Sent: 18/10/2021 2:13:41 PM
Subject: submission re: 14 Prince Alfred Pde, Newport DA2021/1682
Attachments: 14 Prince Alfred Parade NEWPORT - submission.pdf;

**RE: DEVELOPMENT APPLICATION DA (DA2021/1682)
PROPOSED CARPORT, ELEVATED WALKWAY AND LIFT
14 PRINCE ALFRED PARADE, NEWPORT**

Image 1: Survey showing tree located where the entry to the carport is located.

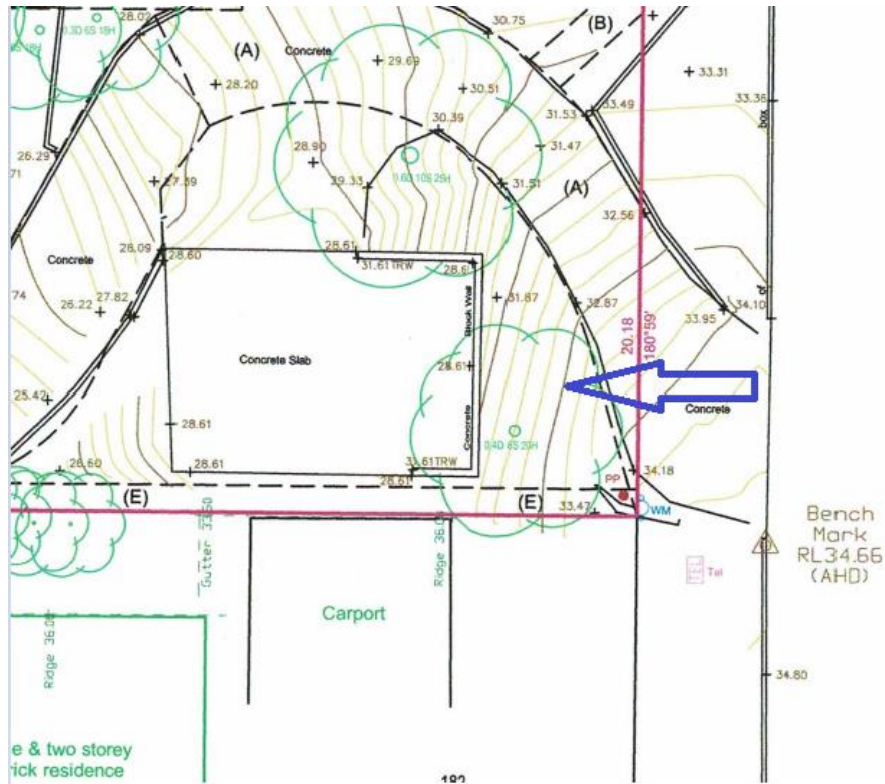
It is also unclear as to how the carport area above is to be accessed. The proposal has the carport level at RL32.130. The plans suggest that you enter the carport via the eastern elevation but that would require a connection to the existing driveway that does not exist and not proposed. The survey provided shows that this arrangement is not feasible due to a tree in that location.

In reality, that tree has already been removed when the unauthorised works were undertaken to the concrete slab. The tree was removed without approval, also. The images below show that no tree is located in front of the carport.

It is obvious that the survey provided does not reflect the current site conditions and a current survey is required. This is discussed further below in section 6.0.

The survey is outdated and lacks detail. A new boundary identification survey and arborist report are required.
